Agenda
Village of Arlington Heights
Design Commission
Community Room, 3rd Floor
33 S. Arlington Heights Rd.
June 22, 2021
6:30 PM

Item: DC#20-054 - Re-Review - Trammel Crow Senior Housing Development -
2045 S. Arlington Heights Rd. - Institutional

STAFF DESIGN COMMISSION REPORT RE-REVIEW

Project Name: Trammell Crow Senior Housing Development
Project Address: 2045 S. Arlington Heights Road

FROM 2020/11/04 DESIGN COMMISSION SUBMISSION

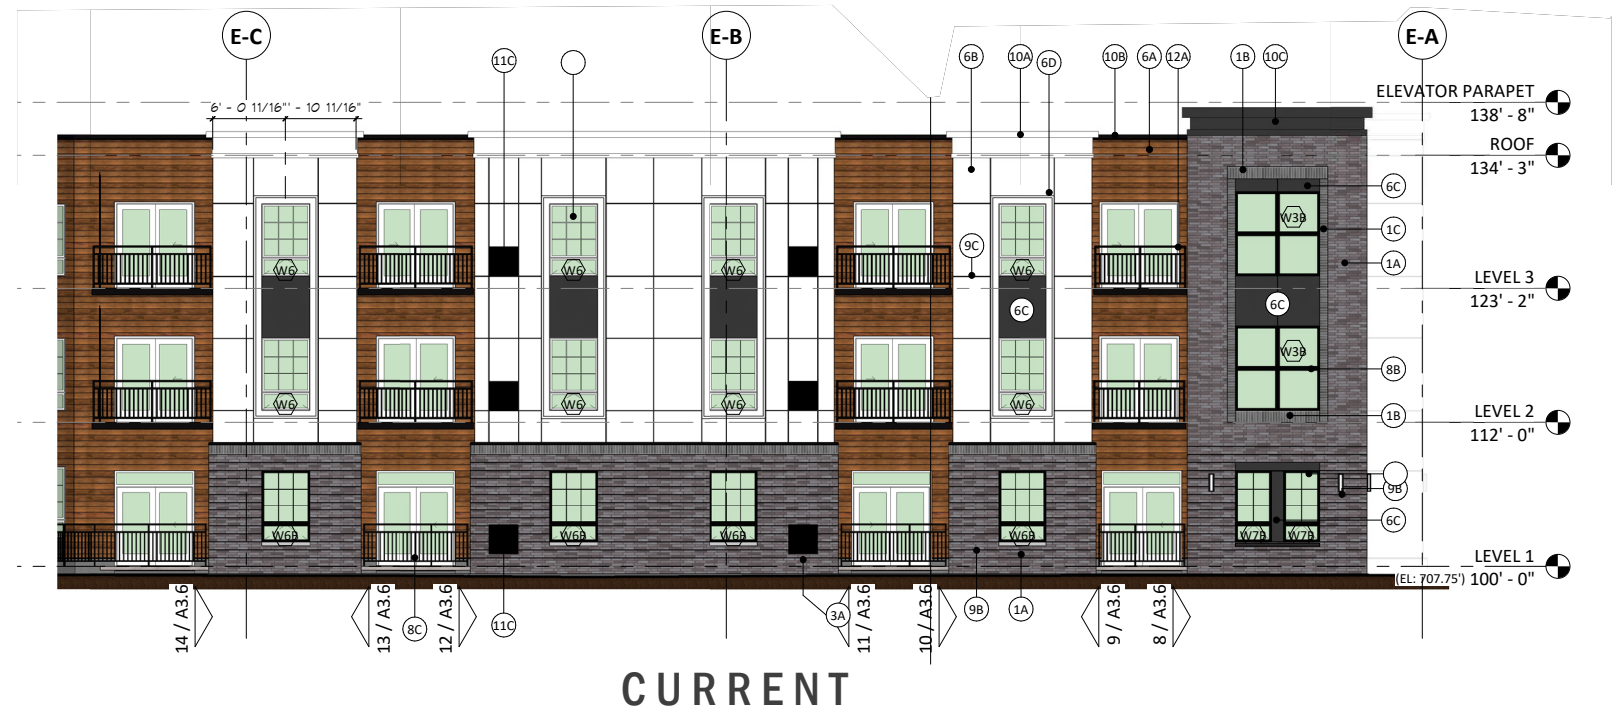
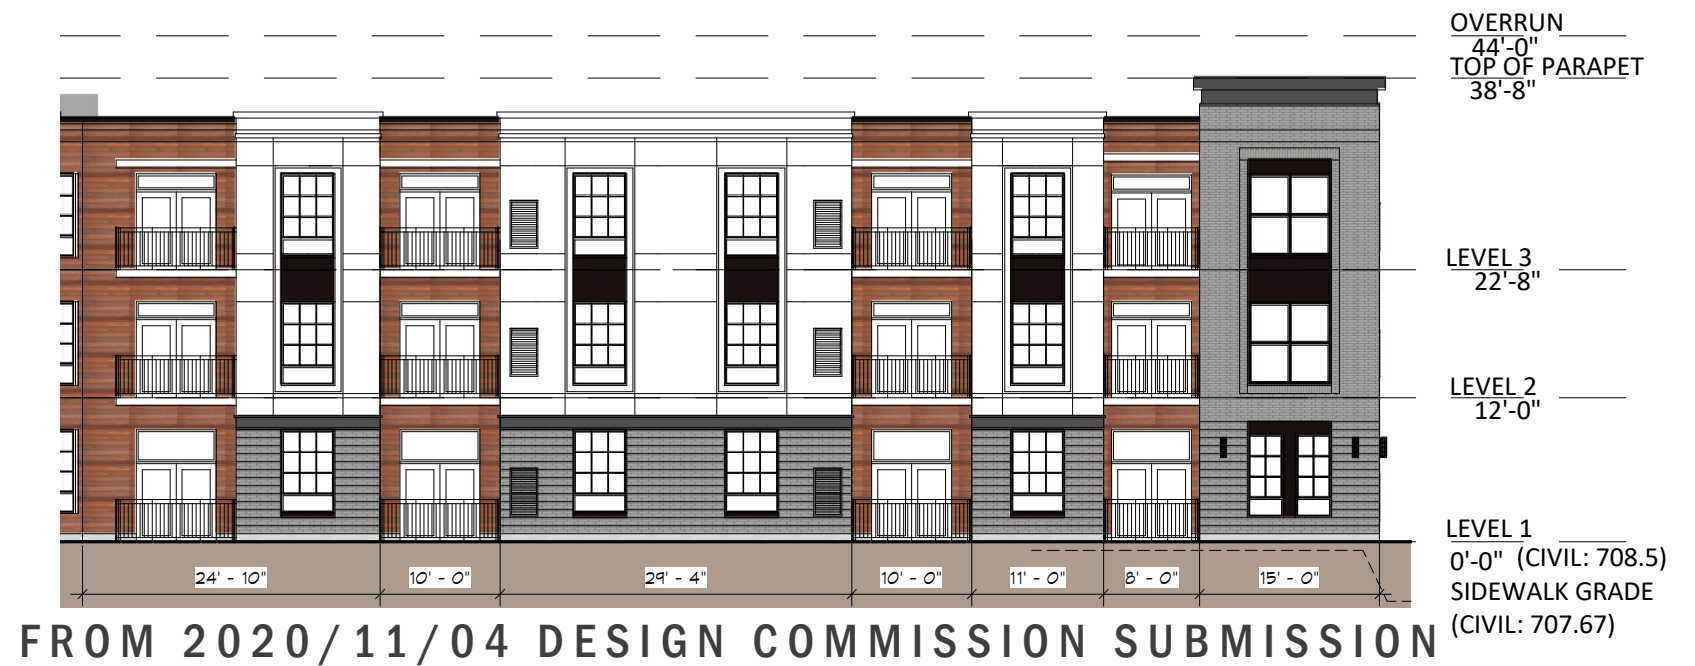
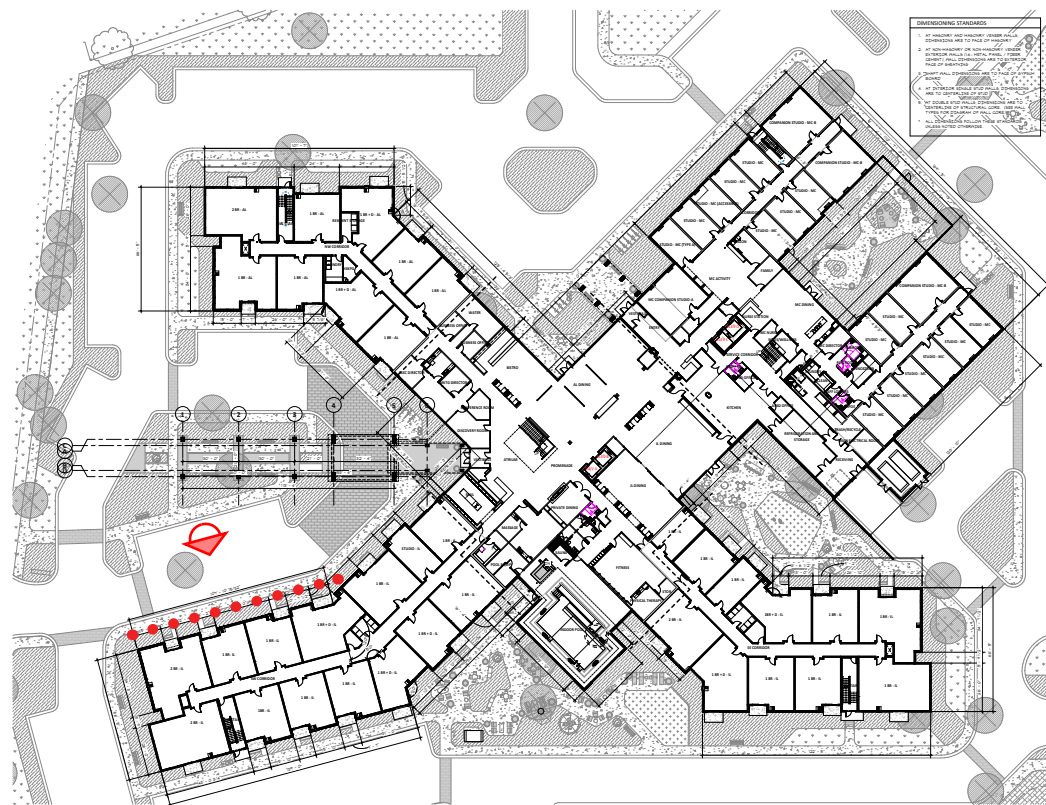
1. Balcony Canopies. All canopies above the top floor balconies have been omitted.
2. Balcony Support Rods. Diagonal balcony support rods have been added to all balconies, except for the semi-recessed balconies.
3. Window Color. The windows within the areas of white and wood siding have been changed from black frames to white frames. Windows within areas of gray brick will remain black.
4. Transom Windows. The transom windows above the Level 2 and Level 3 balcony doors have been omitted.

Staff does not object to the proposed changes to the design, and the overall appearance of the building remains substantially compliant with the previously approved plans. However, the proposed removal of the small canopies above the top floor balconies is not in compliance with the Design Commission's requirement to add canopies (where missing) above all of the balconies. For this reason, Design Commission re-review and approval is required.

- Windows and sliding doors have white frames. Windows and doors within areas of masonry have black frames.
- Canopies above Level 3 balconies have been removed.
- Transoms above Level 2 and Level 3 doors have been removed.
- Balcony support rods were not previously illustrated. They are now shown where necessary.

1. All conditions of approval from November 10, 2020 shall apply, except for the requirement regarding the addition of balcony canopies.
2. This review deals with architectural design only and should not be construed to be an approval of, or to have any other impact on, any other zoning and/or land use issues or decisions that stem from zoning, sign code or building or any other reviews. In addition to the normal technical review, permit drawings will be reviewed for consistency with the Design Commission and any other Commission or Board approval conditions. It is the architect/owner/builder's responsibility to comply with the Design Commission approval and ensure that building permit plans and sign permit plans comply with all zoning code, building code and sign code requirements.

2 EAST - PARTIAL ELEVATION 2
A1-7 1/16" = 1'-0"

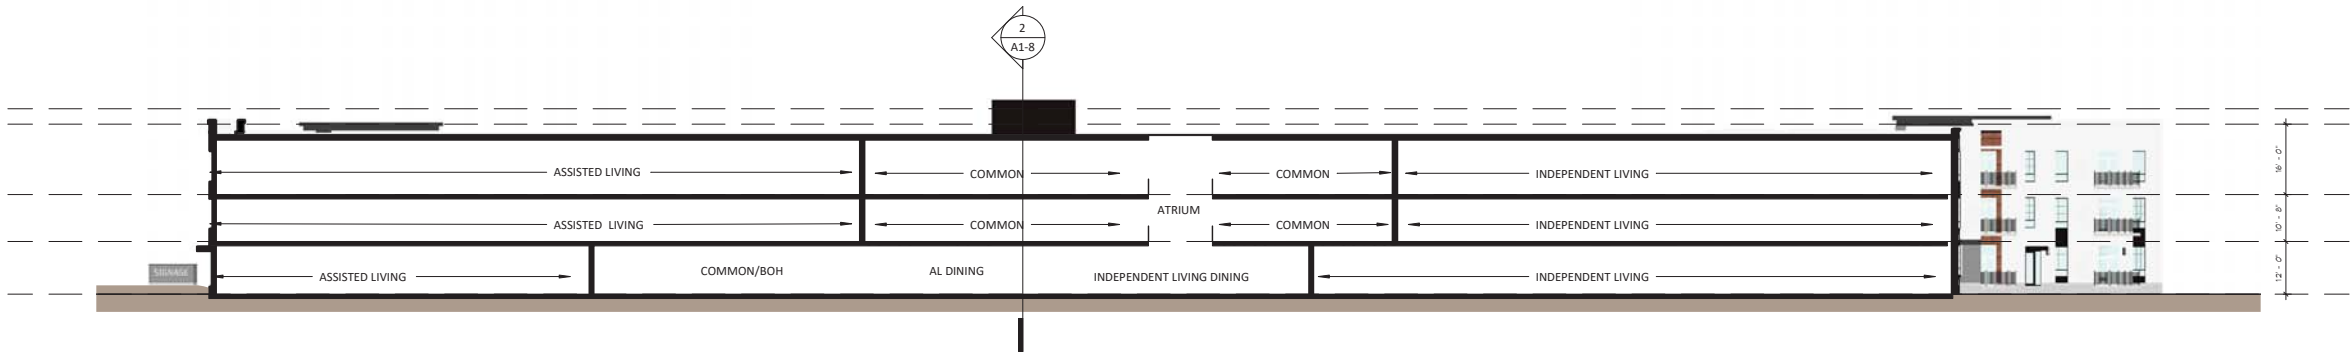
Commissioner Eckhardt referred to Sheet A1-7, East partial elevation 2, which he felt was all over the place with movement, and he asked the petitioner to explain this elevation. Mr. Van Sistine explained that on the left of this elevation where there is brick at the base and the horizontal lines, it implies that the brick would stick out every third or fourth course; that grey brick base and white top is a residential unit expression, which is a different situation than the others because there are balconies here. What happens at the common areas is that the brick is what you feel and see when entering the courtyard area; what happens at the lower portion is that the same horizontal patterning is only happening at the lower base and not carrying it all the way up. They are trying to create interest within the set of rules and stick to them as much as it makes sense and as much as possible without compromising a unit for the rigidity of

SOFFIT/FASCIA

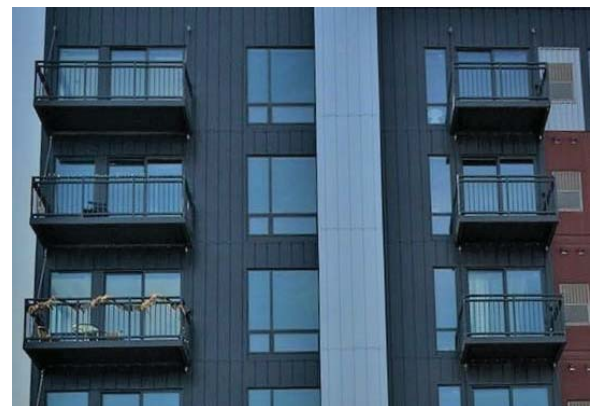
- **Balcony Fascia/Soffit.** The balcony fascia and soffits are proposed to be clad in a light gray metal. It is recommended to consider changing the fascia/soffit color to black for more contrast against the exterior walls, and to coordinate with the black balcony railings.

1. A REQUIREMENT THAT THE FASCIA AT ALL OF THE BALCONIES BE CHANGED TO BLACK TO MATCH

2. A REQUIREMENT THAT THE UNDERSIDE OF THE BALCONIES BE BLACK OR GREY TO MATCH THE BRICK.
3. A REQUIREMENT THAT THE ELEVATOR OVERRUNS BE CLAD IN GREY TO MATCH THE BRICK.

2 PROPOSED SOUTH ELEVATION
SCALE: 1"=10'-0"

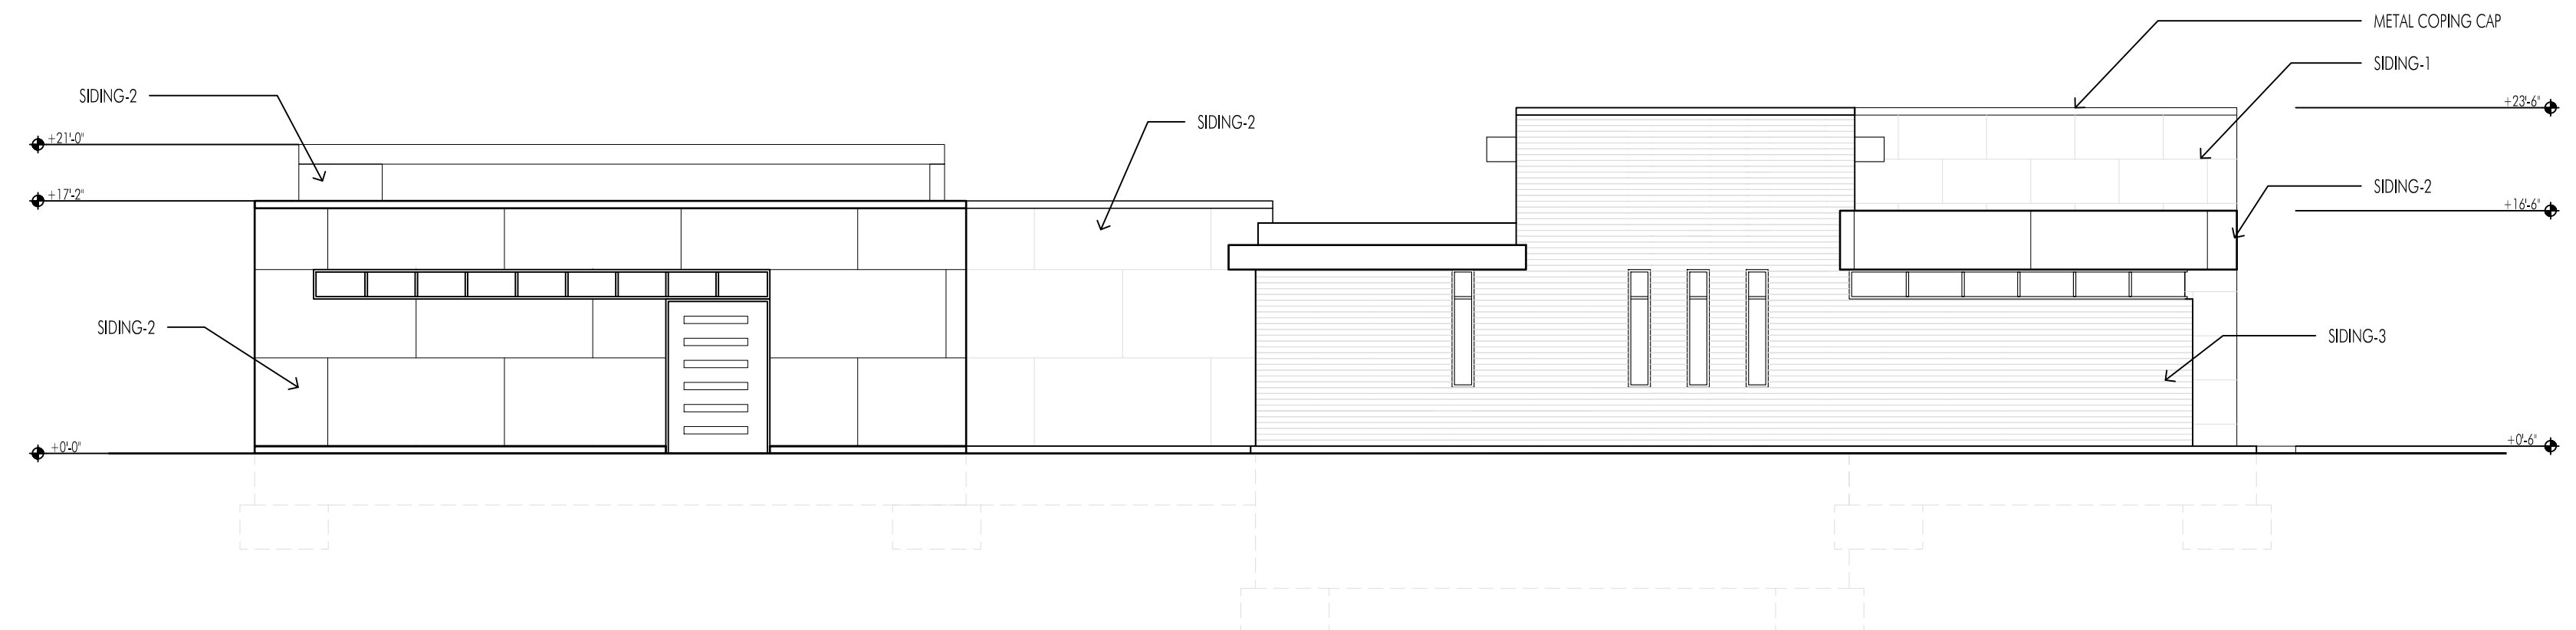
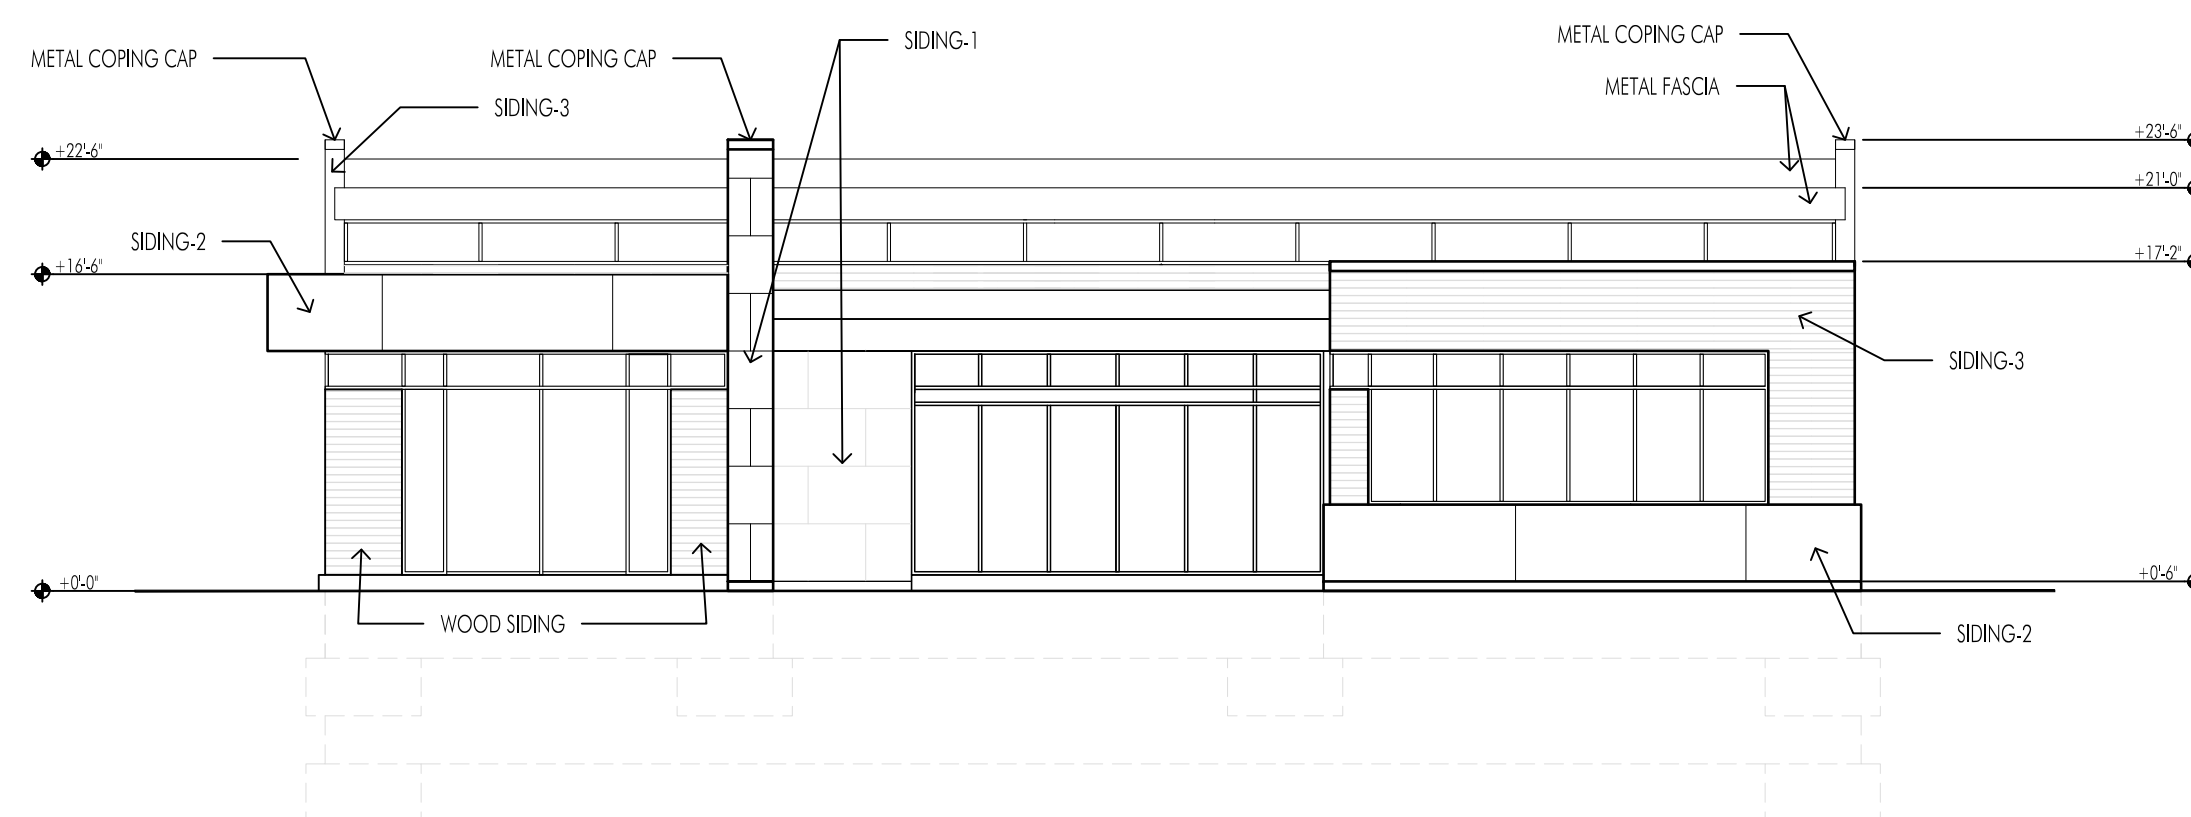
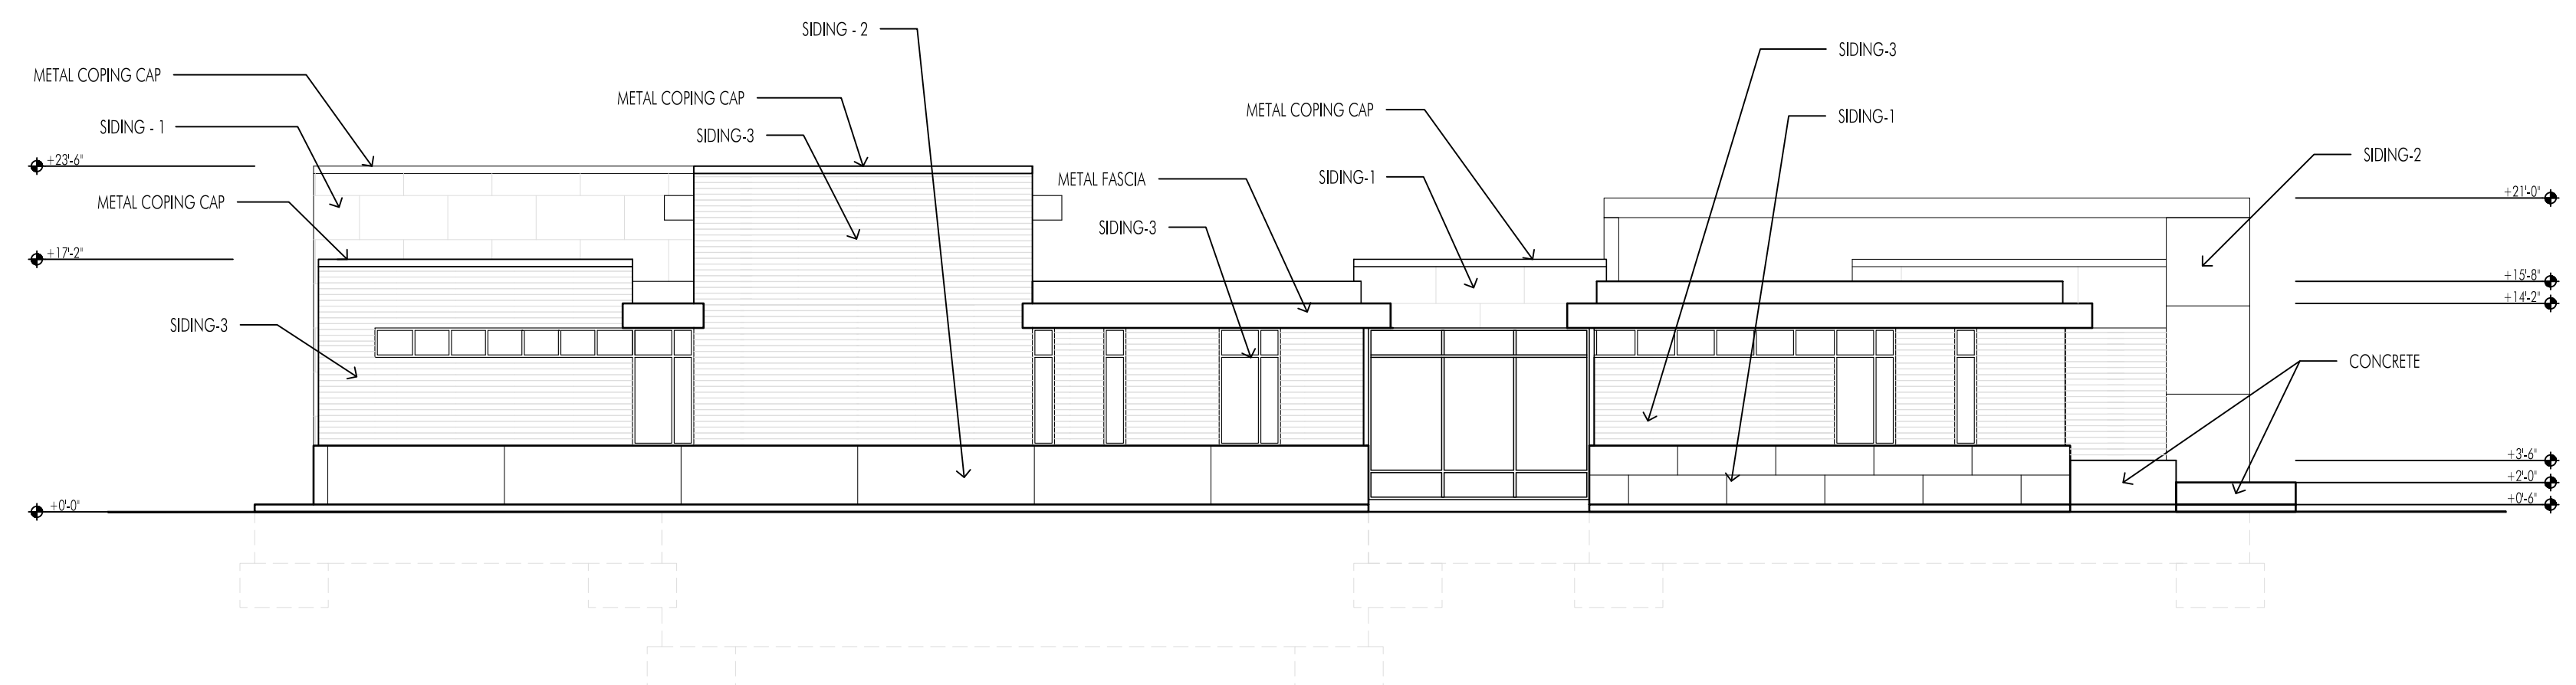
Commissioner Eckhardt said he was okay with the front elevation and the front corner of the home, and he was okay with extending it somewhat down the south elevation; however, he wondered if some of the grey color could be introduced into the big black box across the rear elevation. Mr. Papanicholas clarified that a rendering of the rear elevation was not provided, and the black box Commissioner Eckhardt is referring to is actually the side of the garage on the south elevation, not the rear elevation. Mr. Papanicholas added that a change was made to the south elevation after meeting with Staff; all the mechanical on the south elevation was recessed by jogging the wall back and adding landscaping. He explained that the dark prominent color was chosen because their research showed it to be a complimentary color to the wood, and a color they feel most comfortable with in achieving everything they want to achieve.

Commissioner Eckhardt reiterated that he had no issue with the front elevation; his concerns are when it turns and goes down the side of the home and looks like a big black box. Mr. Huck presented a 3-D rendering showing the south elevation from the adjacent neighbor's front yard, which will not be seen from the further back from the street. Mr. Papanicholas added that there will be 10-foot setbacks on the sides of the home. Mr. Huck explained that the rendering makes the dark color look very black, when it is actually a charcoal color. Commissioner Eckhardt said that he was satisfied with the black aesthetic of the massing on the side elevation and the garage.

A MOTION WAS MADE BY COMMISSIONER KINGSLEY, SECONDED BY COMMISSIONER ECKHARDT, TO APPROVE THE PROPOSED ARCHITECTURAL DESIGN FOR THE NEW SINGLE-FAMILY HOME TO BE LOCATED AT 801 N. FORREST AVENUE. THIS APPROVAL IS SUBJECT TO COMPLIANCE WITH THE PLANS DATED 10/05/18 AND RECEIVED 10/22/18, REVISED SITE PLAN, EXTERIOR ELEVATIONS, AND MATERIAL LIST DATED AND RECEIVED 10/30/18, DESIGN COMMISSION RECOMMENDATIONS, COMPLIANCE WITH ALL APPLICABLE FEDERAL, STATE, AND VILLAGE CODES, REGULATIONS, AND POLICIES, THE ISSUANCE OF ALL REQUIRED PERMITS, AND THE FOLLOWING:
